Millstone Nuclear Power Station, Unit 3
NRC Chemical Engineering Branch (Fire Protection)
Review Meeting, March 28, 1984

Status of the NRC-CMEB (Fire Protection)
Draft SER Open Items Discussed at the Meeting
with the NRC-CMEB March 28, 1984

Responses to the Draft SER Open Items

SKETCH 'A'

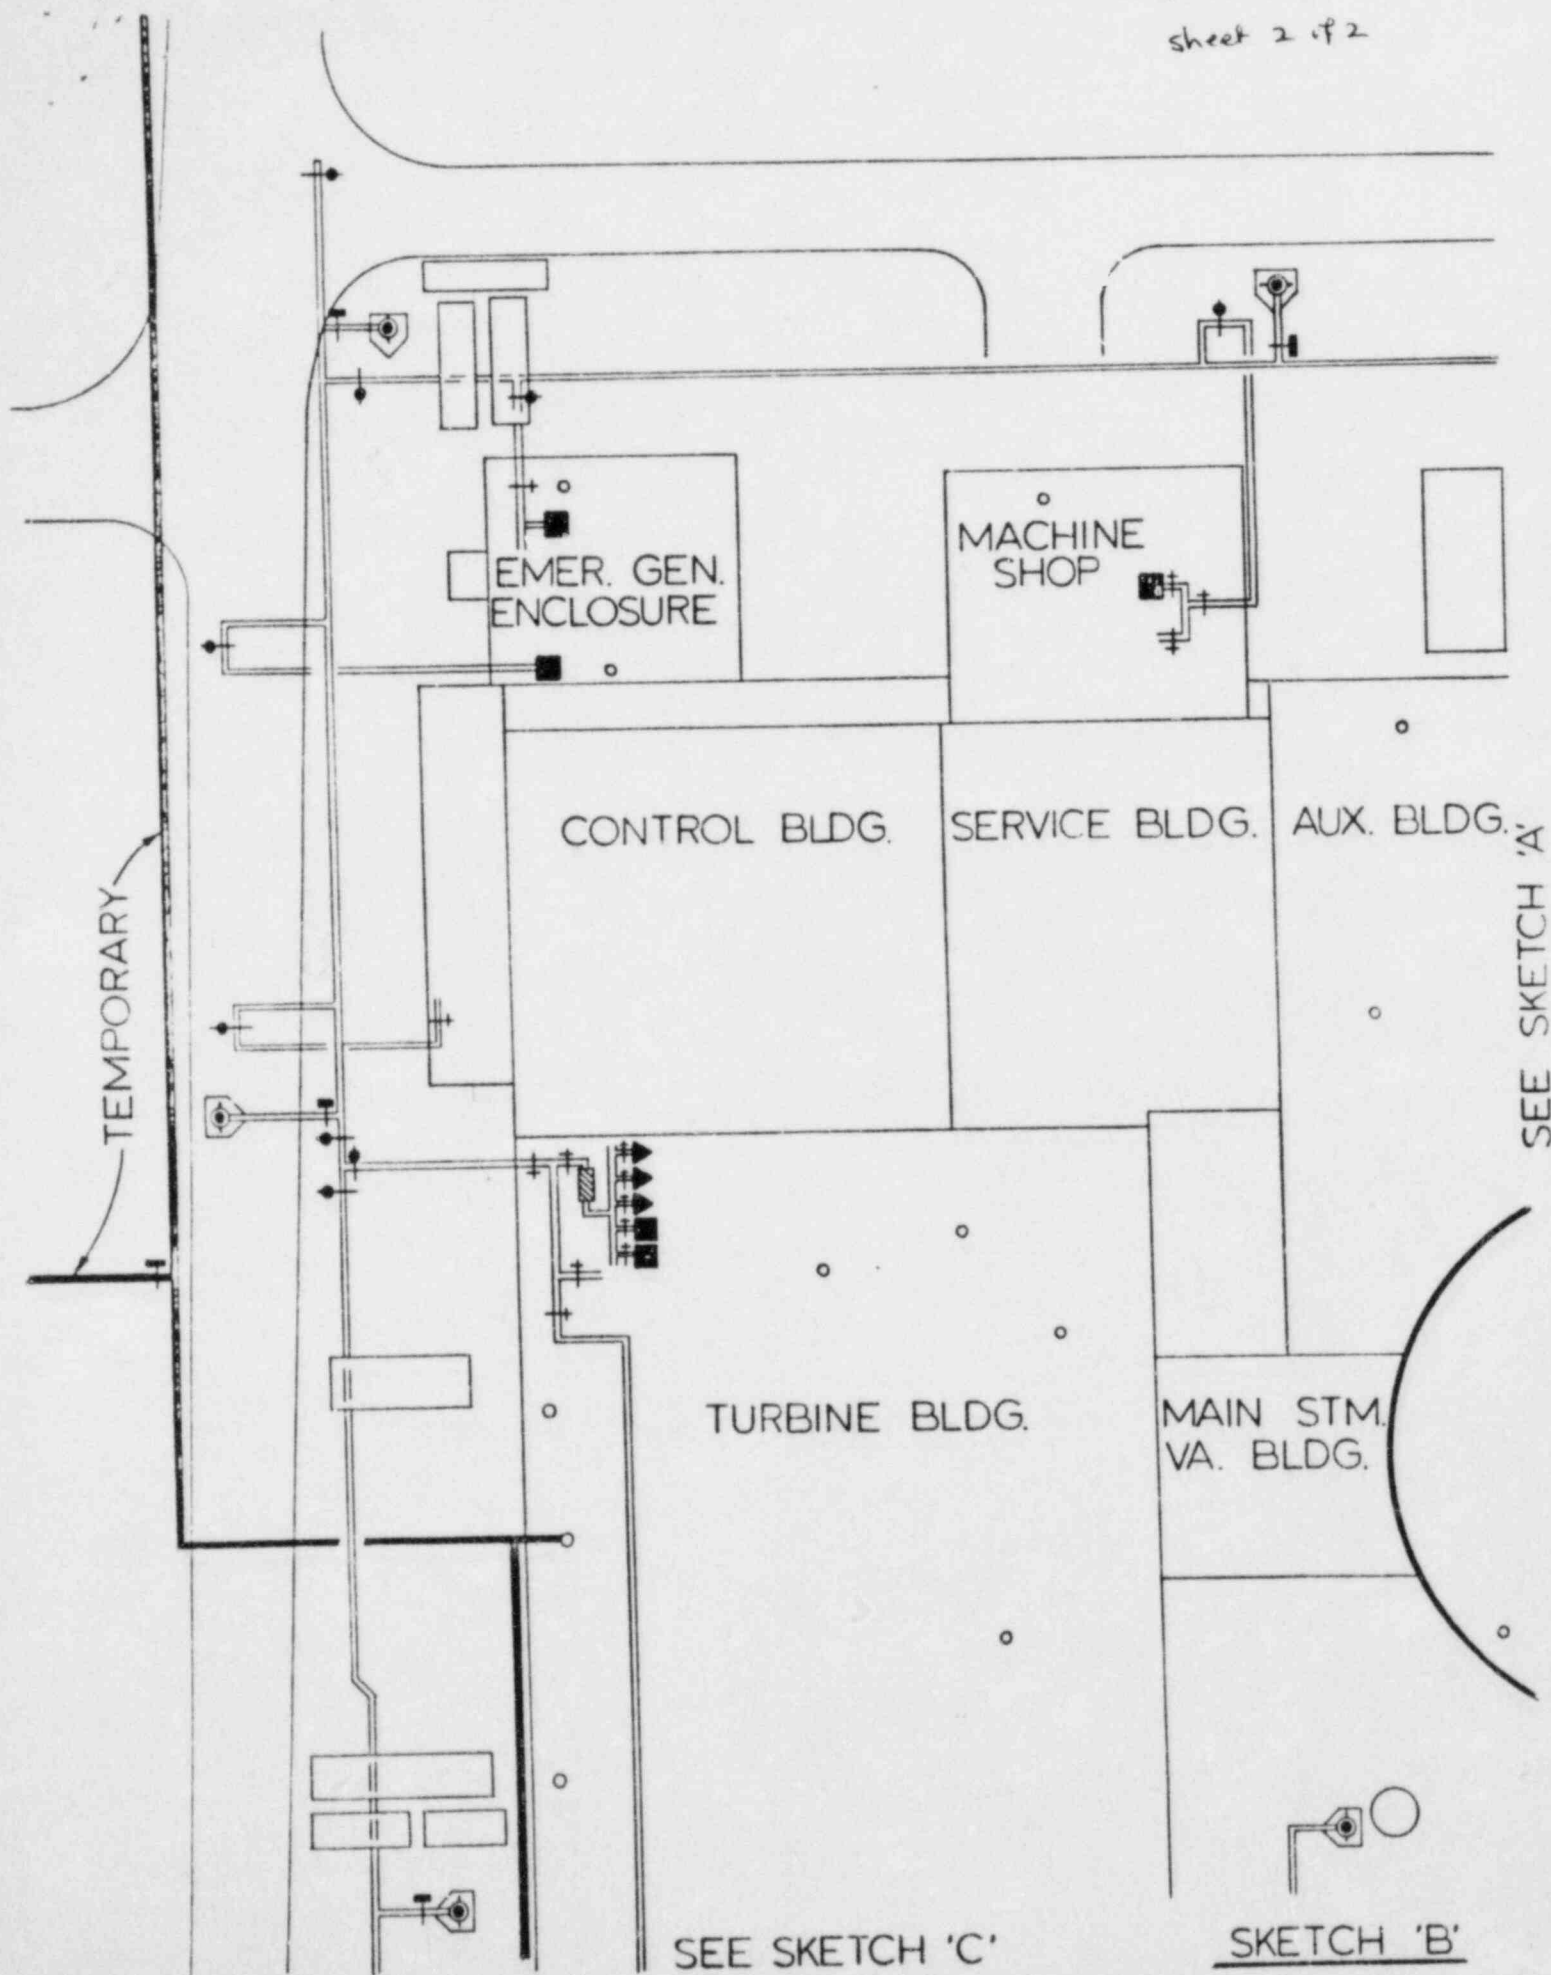
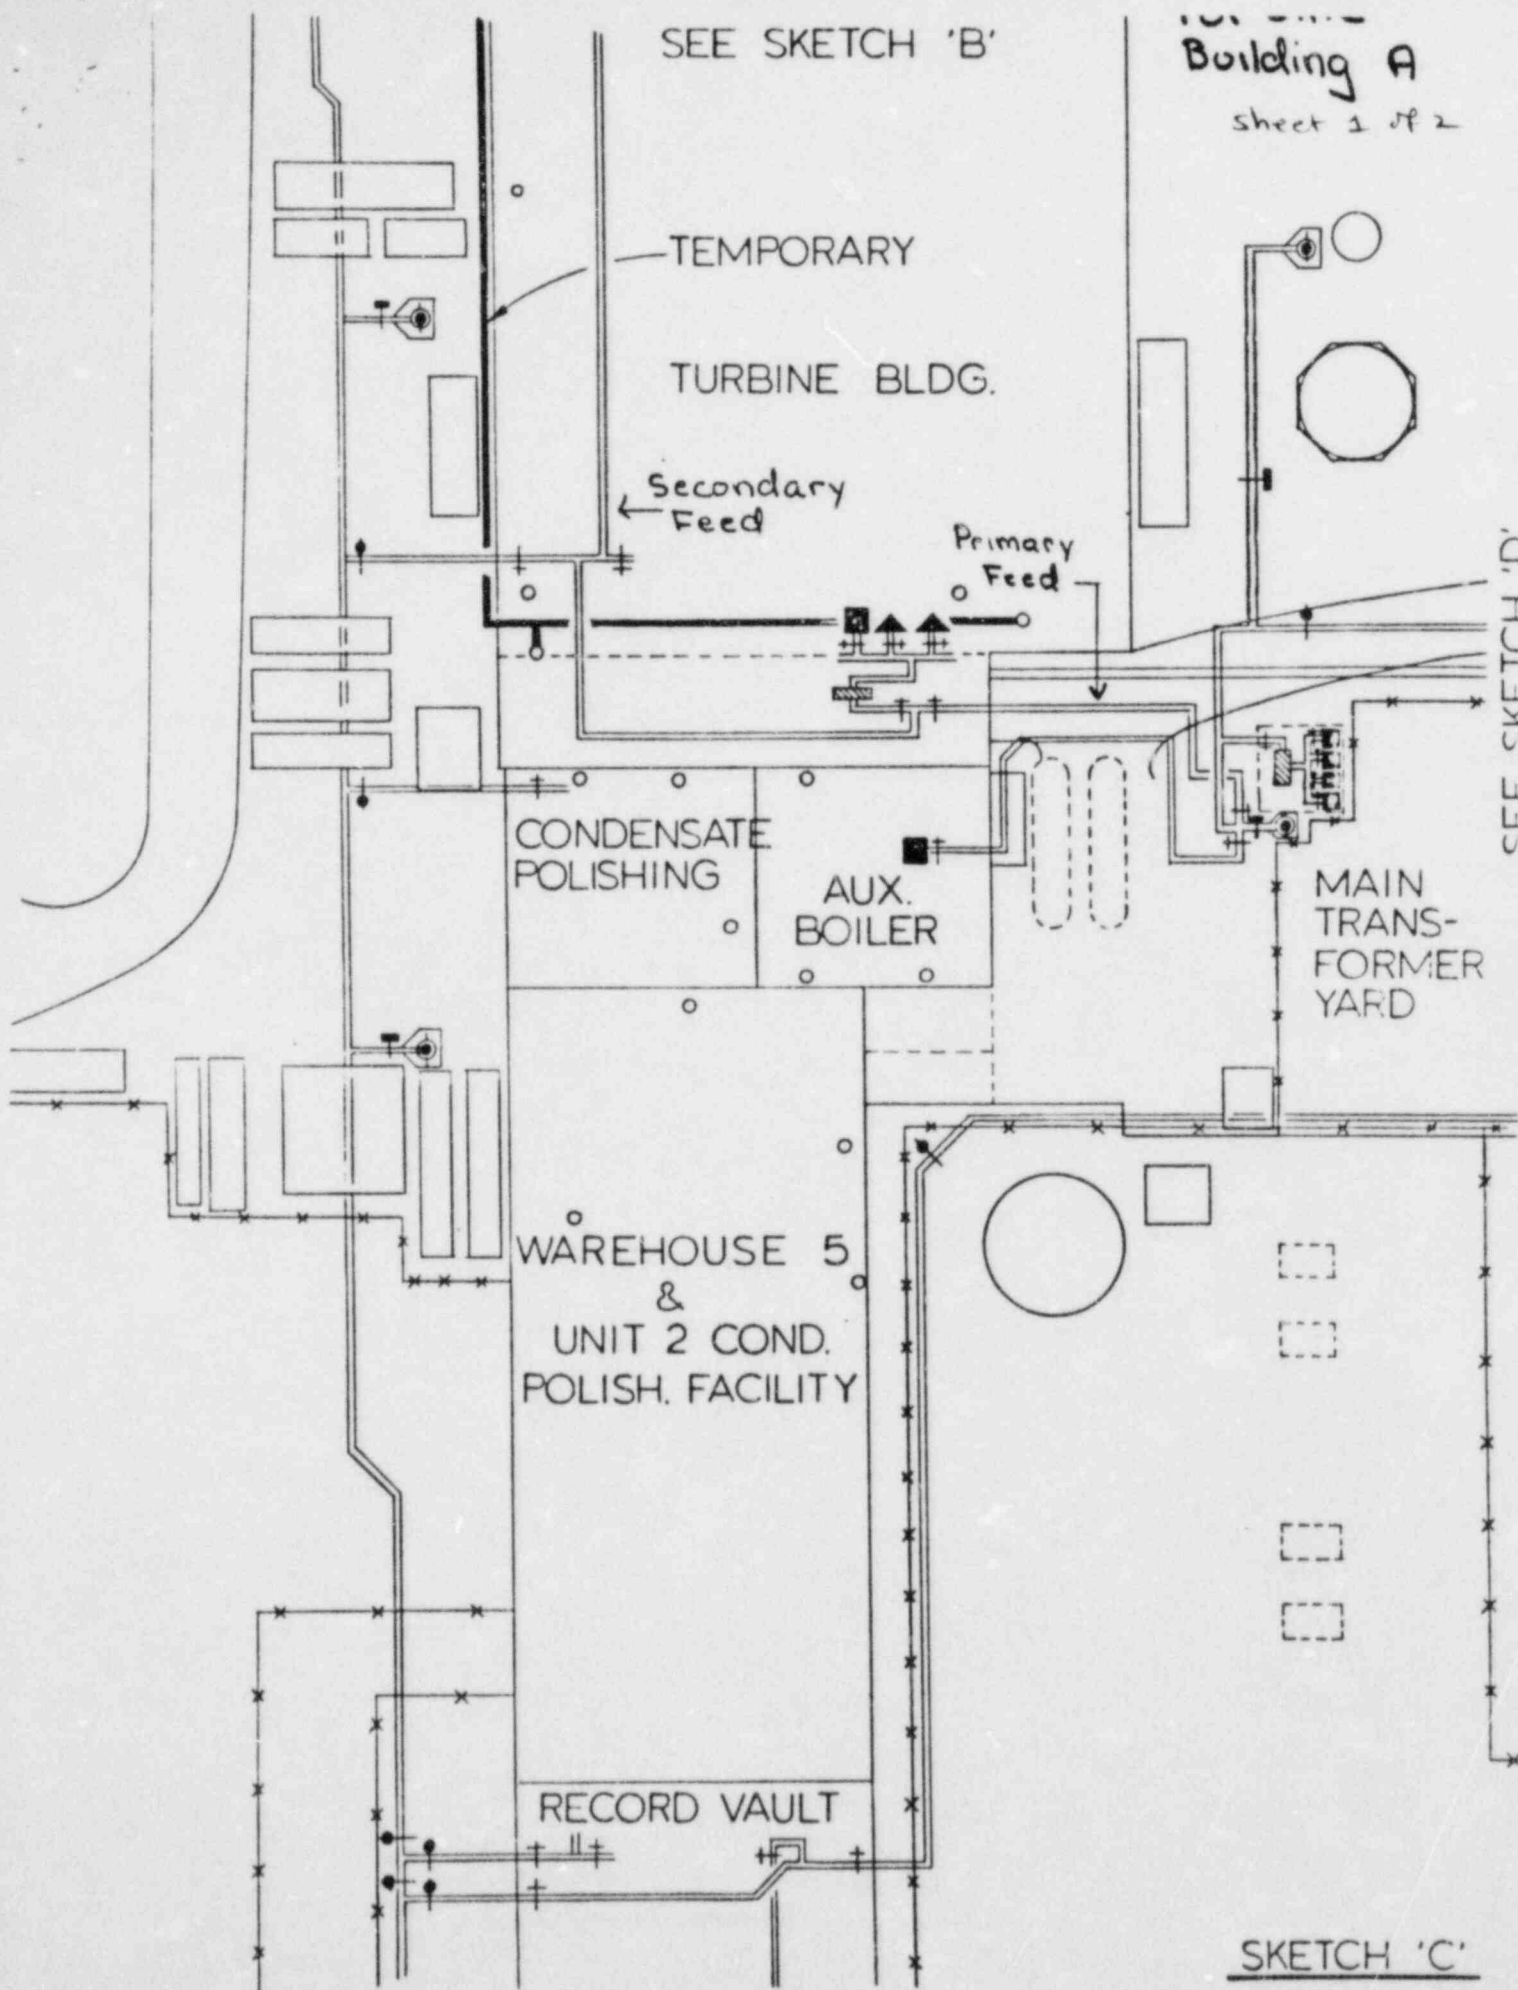
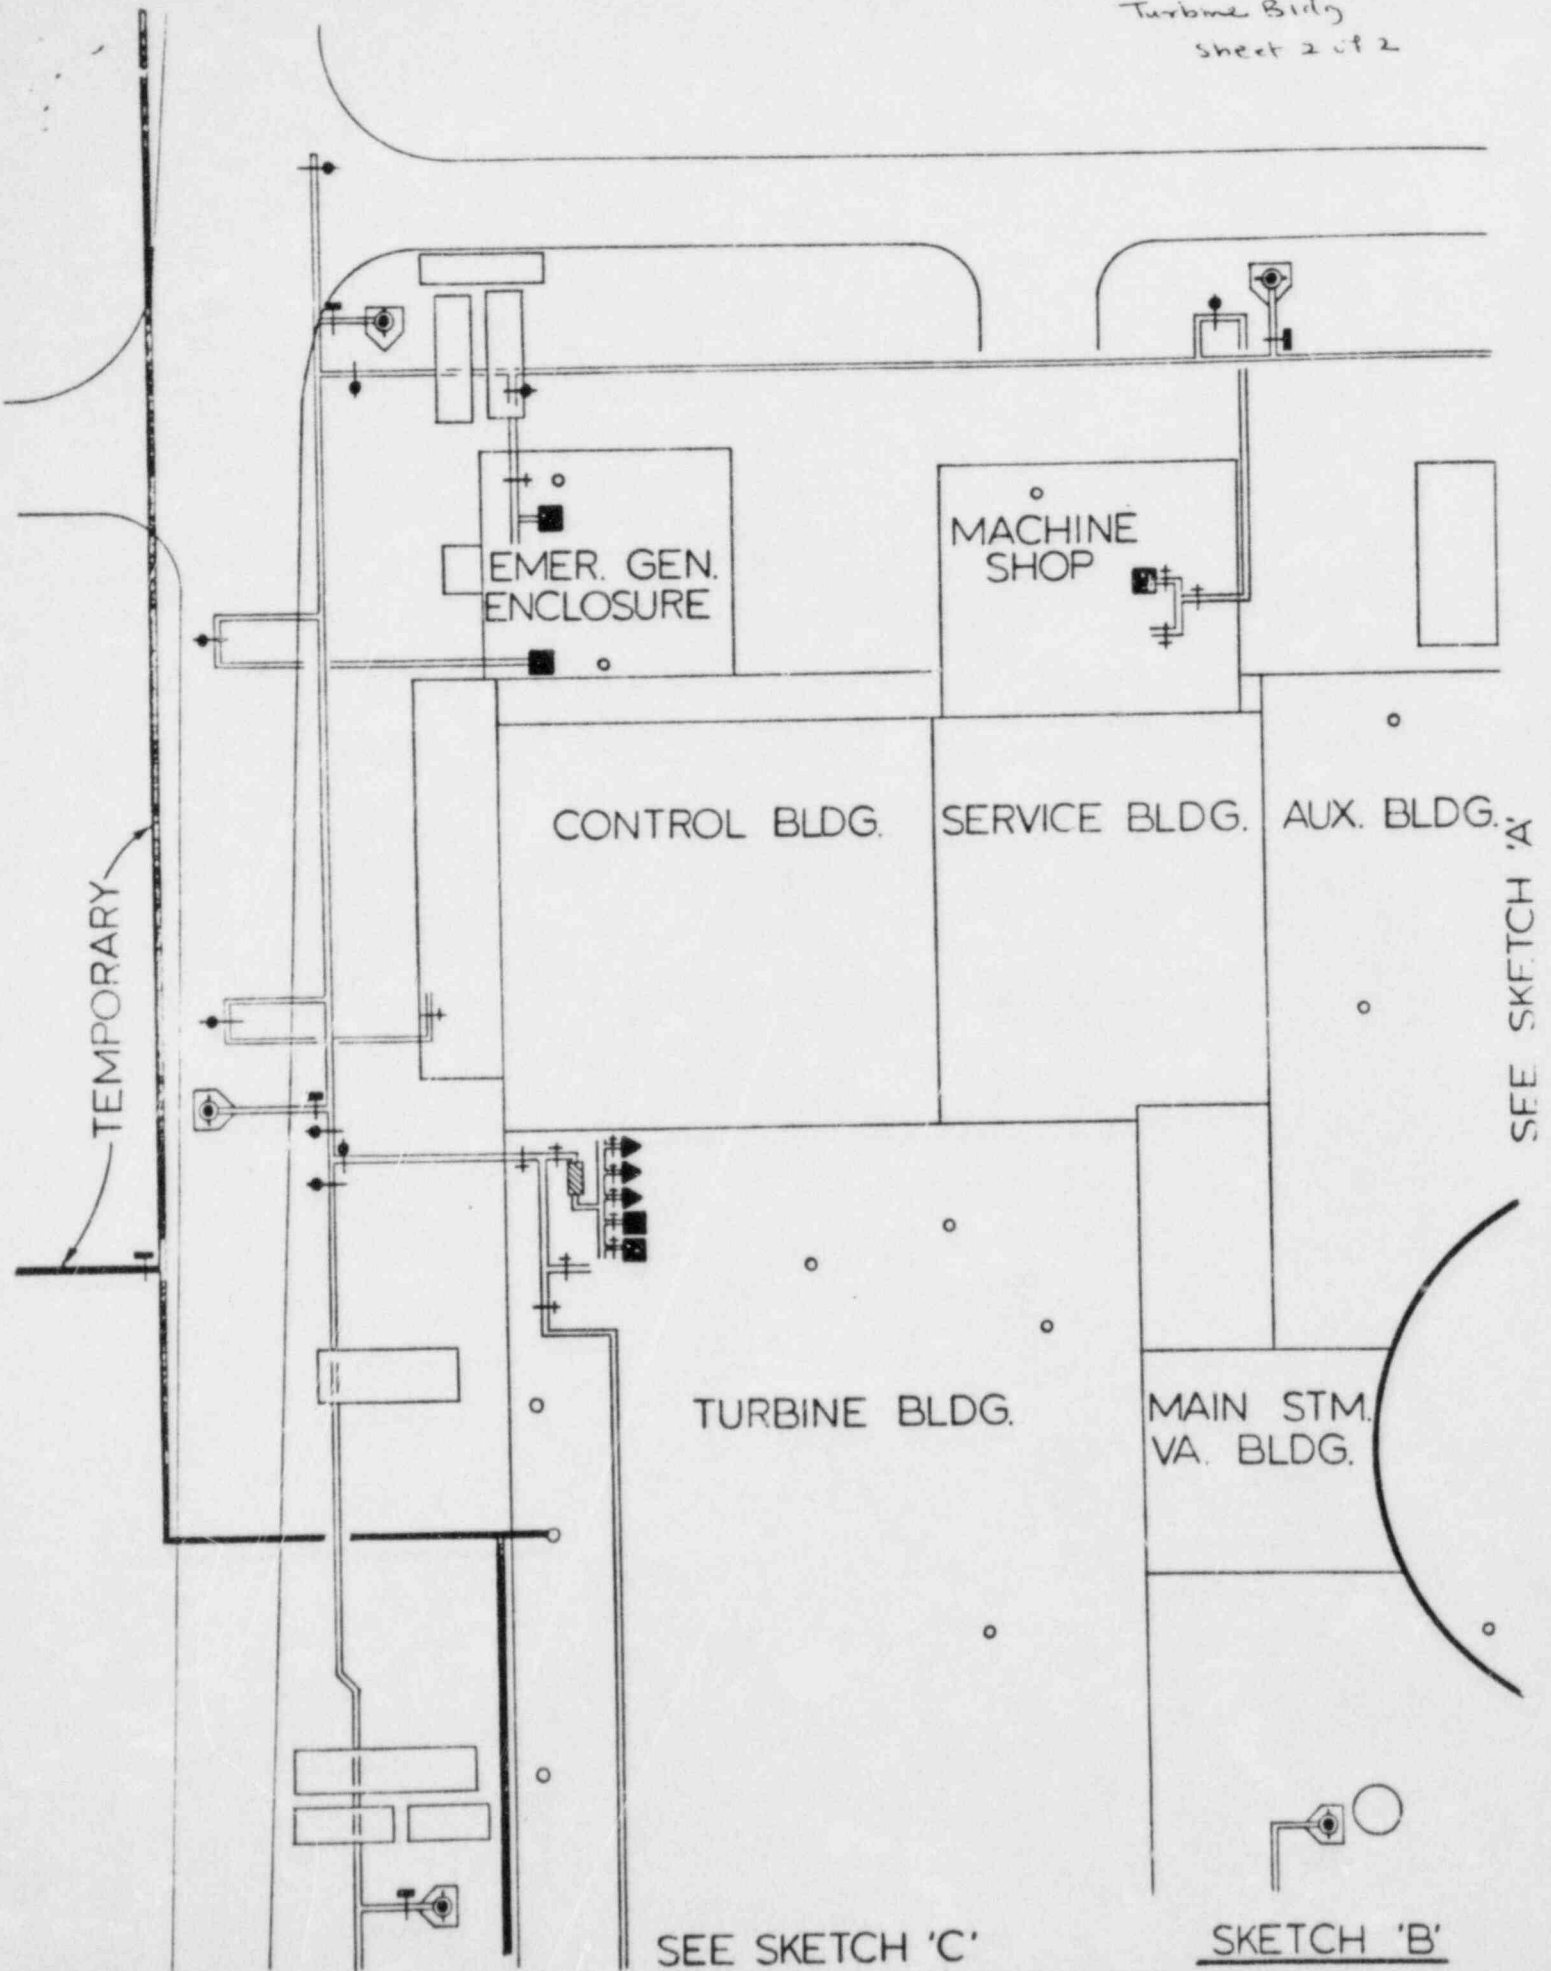
We will require the applicant to provide a fire protection water supply for the emergency generator enclosure, service building, waste disposal building, containment and the auxiliary boiler room such that a single break or failure in the supply piping will not result in the loss of both the primary and secondary water supplies. This is an open item.

The design of the underground fire water supply system at Millstone Unit No. 3, as illustrated on attached sketches A through D, is such that a minimum number of fire water suppression systems would be affected by a single break or failure. This same philosophy has also been utilized in the design of the plants interior fire water suppression systems. It is NNECO's concept should a break or failure occur in the fire water supply piping at Millstone Unit No. 3 to either:

- o Temporarily supply those fire water suppression systems rendered inoperable utilizing large diameter fire hose (2½ inch). Fire hose of sufficient quantity and size would be utilized to adequately supply the inoperable systems. These fire hoses would be supplied from fire hydrants connected to the underground fire water supply system that are unaffected by the break and/or failure. (See Table FP14-1).
- o Provide adequate manual fire suppression capability, in those areas affected by the pipe/break failure, by routing fire hoses from adjacent operable portions of the fire water system.

1. Those portions of the fire water supply piping highlighted in yellow are considered inoperable based upon a pipe break.
2. The primary temporary supply is the shortest route/discharge to an operable yard hydrant/water source.
3. The secondary temporary supply is the alternate source to the primary should it be unavailable.
